CITY OF PORTSMOUTH
Department of Public Works

Bid #02-10

SOUTH MEETING HOUSE REPAIRS

Addendum #1

CITY OF PORTSMOUTH DEPARTMENT OF PUBLIC WORKS		
Title SOUTH MEETING HOUSE SNOW FENCE DETAIL	Bid No. 02-10	Drawn by DJH
Date 1/21/09

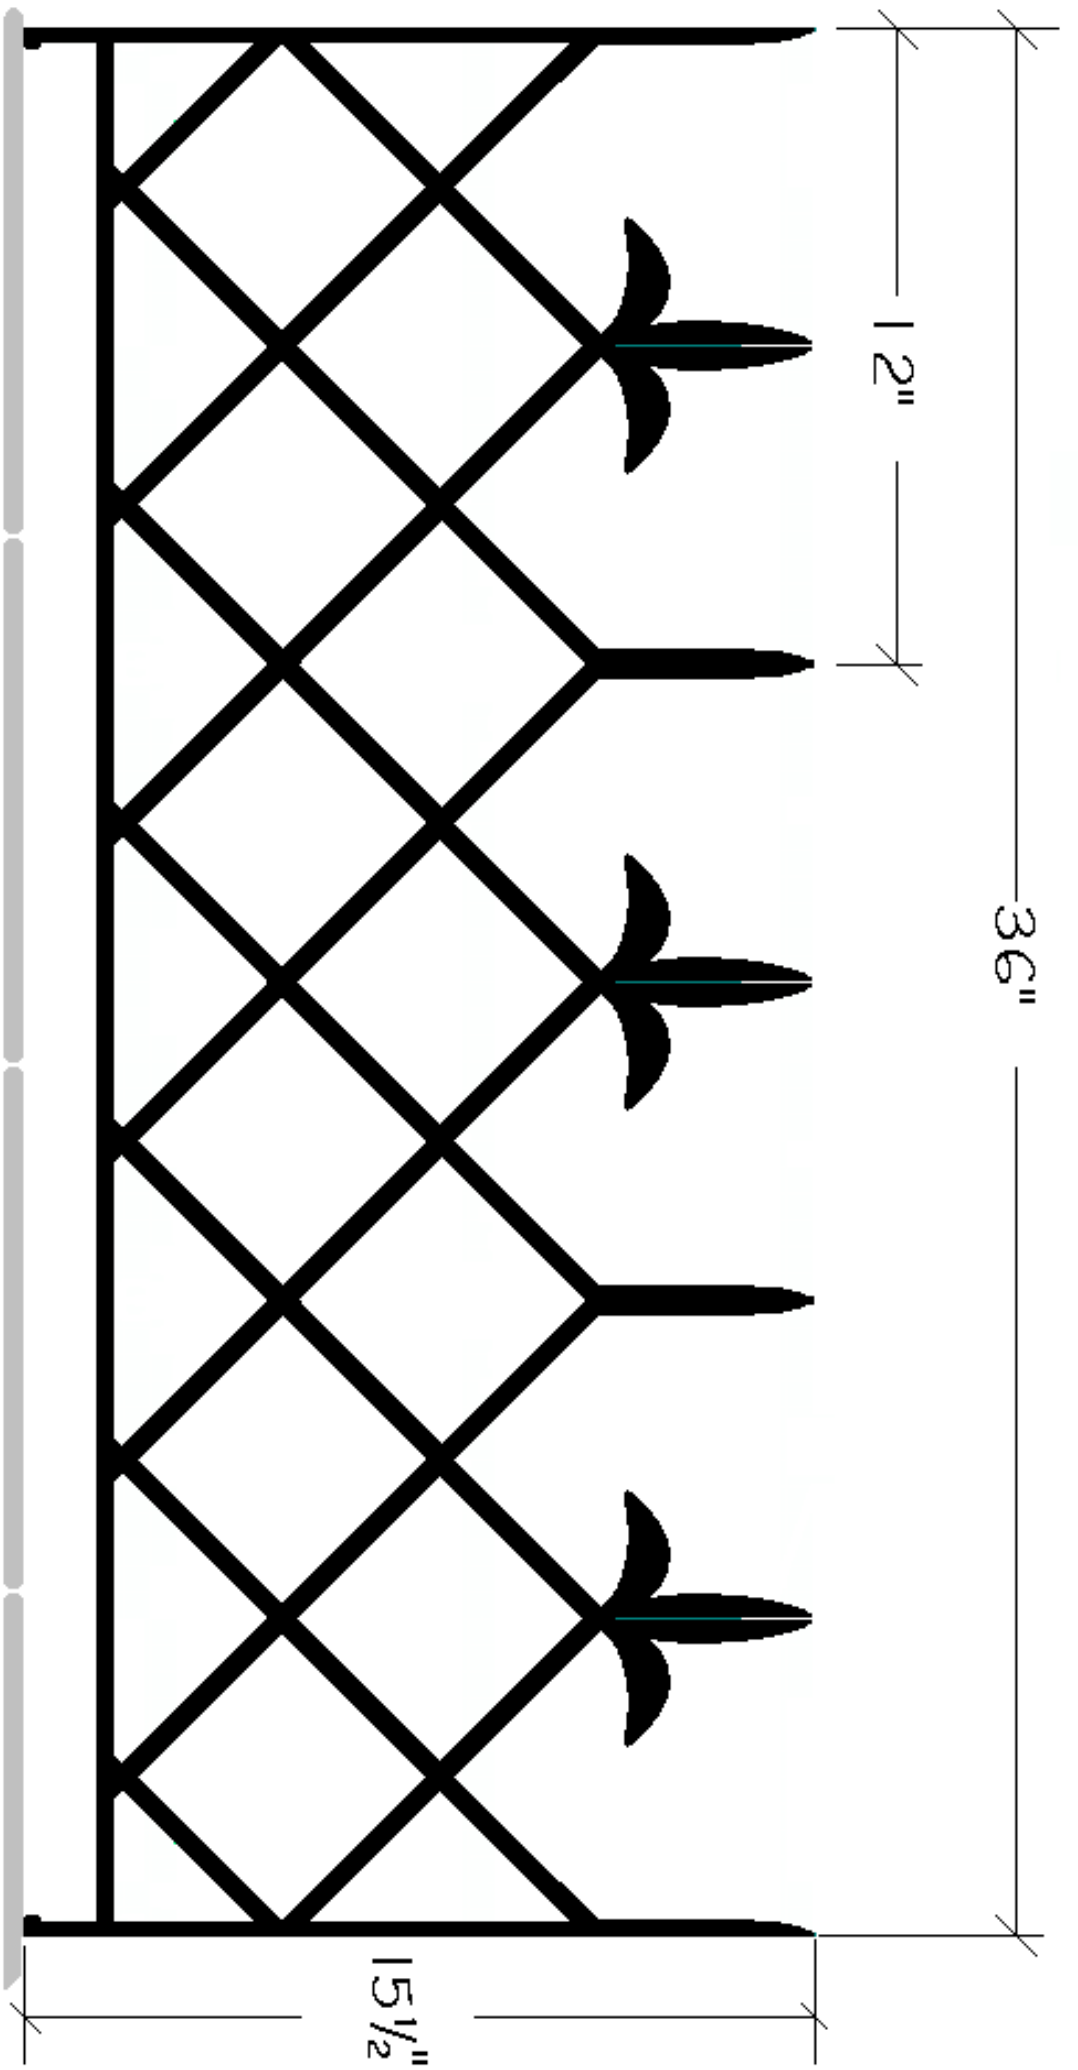
C. DECORATIVE SNOW FENCE (Bid Alternate)

1. Furnish and install decorative snow fence to new two pipe system on north side of roof, to match existing in appearance on south side.

DRAWING 3 SNOW FENCE DETAIL (attached)

NOTE: Snowguards are made of cast iron.
